Time Sweater Limited

Kutubail, Katherpul, Fatullah, Narayanganj, Dhaka, Bangladesh

Survey Date: 13th April 2015

Observations

High Column Stress:

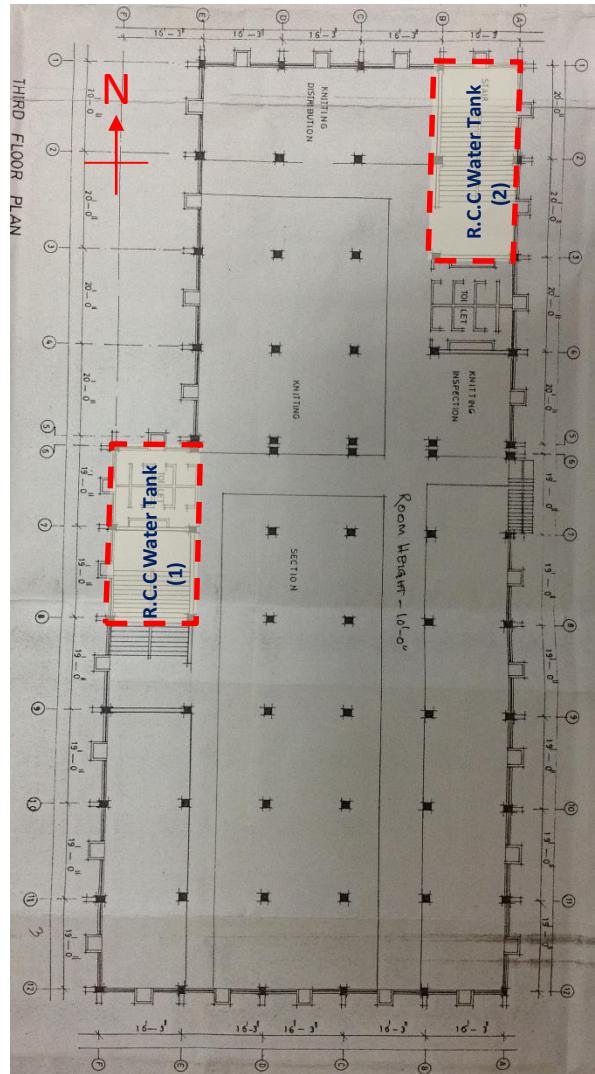
Columns at Ground and First floor levels throughout the building appear to be stressed to levels that are in excess of recommended values.

Columns in areas under water tanks and under toilets appear to be very highly stressed.

Immediate actions are required as noted in the Priority Actions section of this report to reduce the column stresses

Item No.	Observation	Recommended Action Plan	Recommended Timeline
1	High Column stress Water tanks at Roof Level	Empty Water tanks on roof. Provide isolated small plastic water tanks distributed in the roof area as directed by the Factory Engineer.	Immediate - Now
2	High Column stress Water tanks at Roof Level	Remove dead and live loading on all floors as noted on next page.	Immediate - Now
3	High Column stress Water tanks at Roof Level	Factory Engineer to review design, loads and columns stresses in all areas.	Immediate - Now
4	High Column stress Water tanks at Roof Level	Factory Engineer to determine reinforcement in ground level columns immediately	Immediate - Now
5	High Column stress Water tanks at Roof Level	Verify insitu concrete strengths by taking a minimum of 4 no. 100mm diameter cores from columns at ground floor	Immediate - Now
6	High Column stress Water tanks at Roof Level	A Detail Engineering Assessment of Factory to be commenced, see attached Scope	Immediate - Now

7	High Column stress Water tanks at Roof Level	Produce and actively manage a loading plan for all floor plates within the factory giving consideration to floor capacity and column capacity.	6-weeks
8	High Column stress Water tanks at Roof Level	Detail Engineering Assessment to be completed	6-weeks

Water tanks at Roof Level

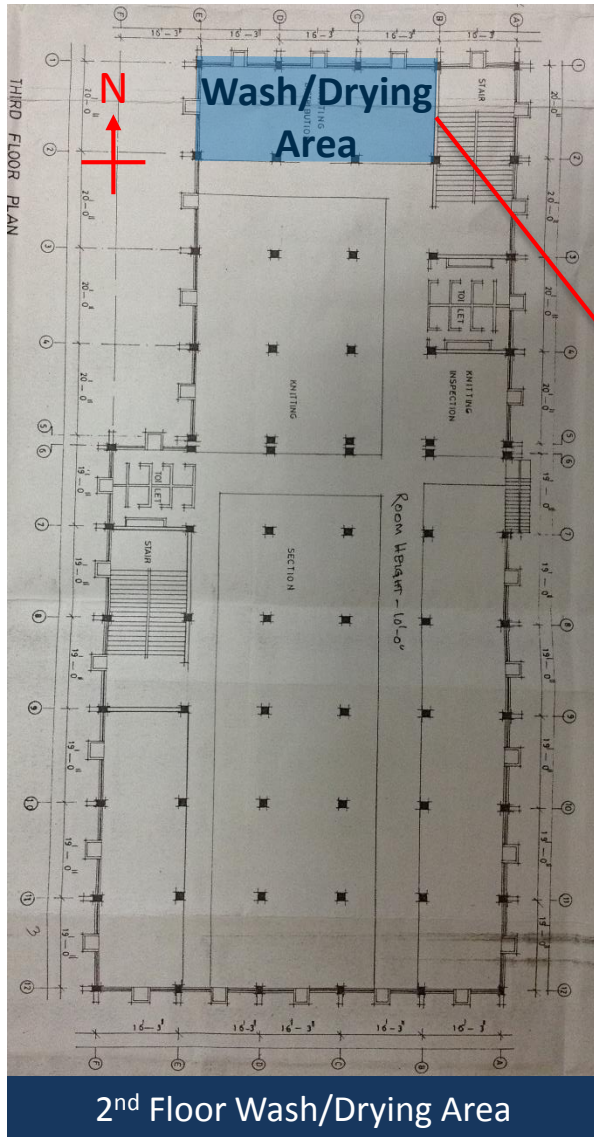
65,000 Litre R.C Water tank (1)

65,000 Litre R.C Water tank (2)

Partially Demolished construction at roof level

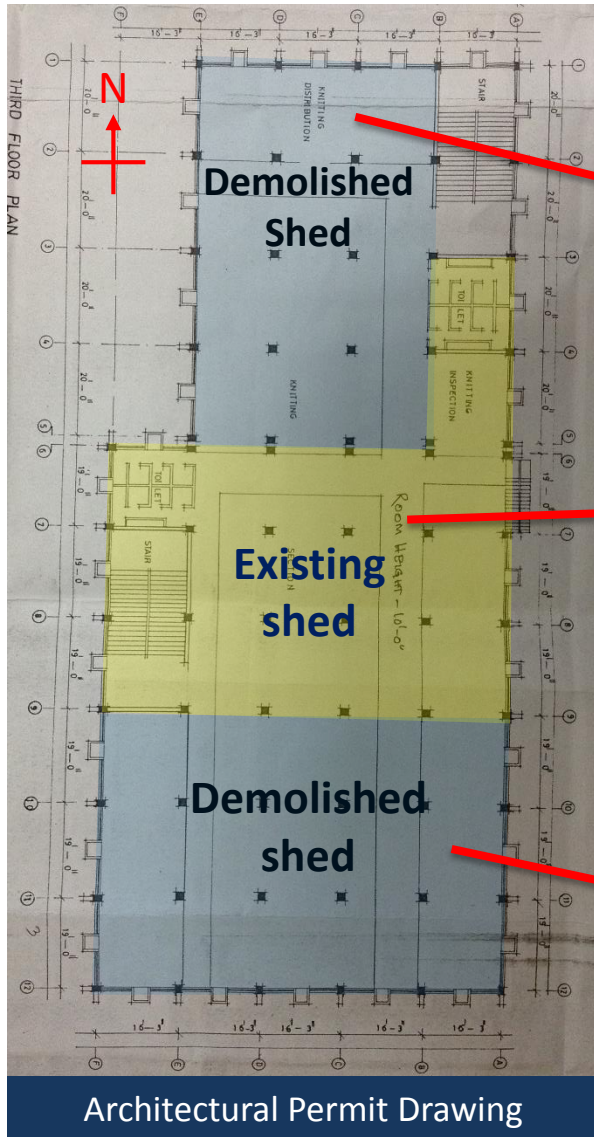
Shed at roof level is partially demolished

Cracked Column at Porch (G-10)

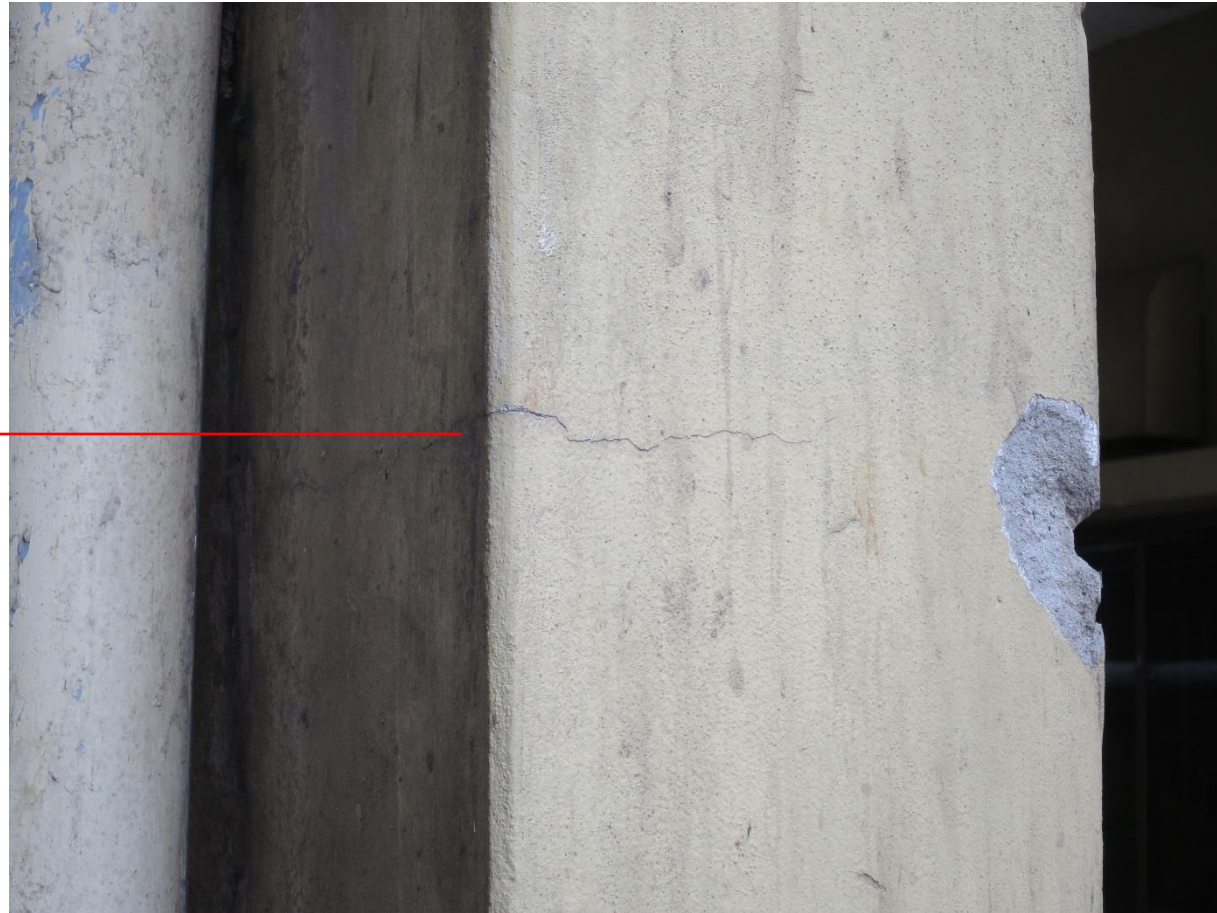
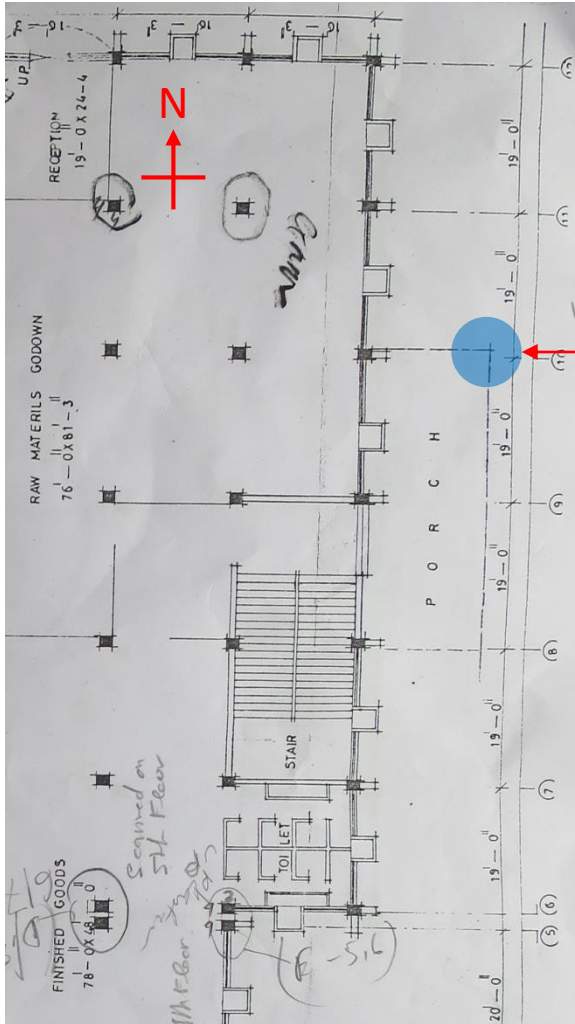
Cracking in column at porch

Item No.	Observation	Recommended Action Plan	Recommended Timeline
9	Raised Floor at Washing and drying Area on 2nd Floor	As part of the Detailed Engineering assessment (see Item1) Factory Engineer to verify that the 2nd floor slab and beams can safely carry the superimposed dead load resulting from raised floor build-up (circa 230mm) along with all other dead and imposed loads.	6-weeks
10	Raised Floor at Washing and drying Area on 2nd Floor	Carry out any remedial actions as directed by the Factory Engineer.	6-weeks
11	Removal of partially demolished construction at roof level	Factory Engineer to ensure all remaining walls and steel roof construction at roof level are demolished and removed.	6-weeks
12	Cracked Column at Porch (G-10) on Ground Floor	As part of the Detailed Engineering Assessment (see Item 1) Factory Engineer to assess structural capacity of existing cracked column under Porch (G-10) and recommend replace/repair as necessary, if required.	6-weeks

13	Cracked Column at Porch (G-10) on Ground Floor	Carry out any remedial actions as directed by the Factory Engineer.	6-weeks
